MIL "ON" DTC P2820

Service Category Drivetrain

Section CVT

Applicability

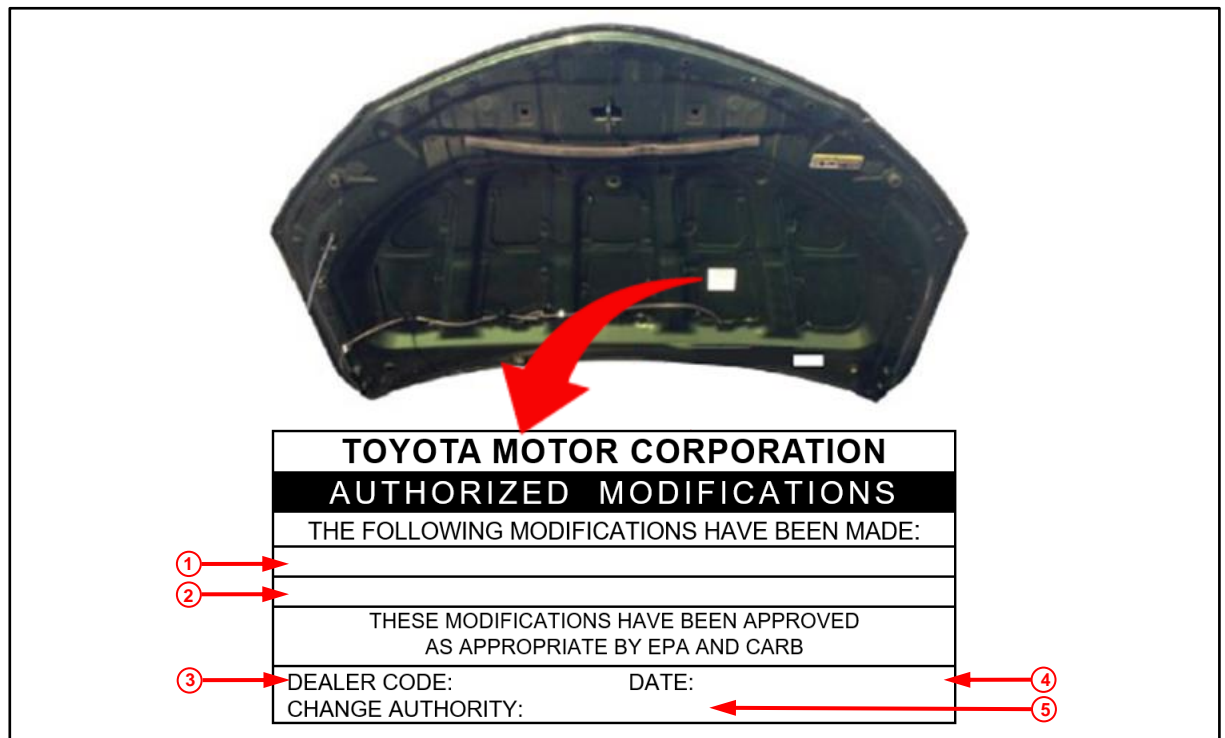
Do NOT complete the following steps:

- Step 16: Remove Torque Converter Assembly
 - Step 17: Remove CVT Oil Pump Type T Oil Seal
 - Step 23: Remove With Head Straight Screw Plug
 - Step 24: Remove No. 1 Breather Plug (CVT)
3. Install the replacement CVT.
Refer to TIS, applicable model and model year Repair Manual:
 - 2016 iM:
Drivetrain – CVT – [“K313 CVT: Continuously Variable Transaxle Assembly: Installation”](#)
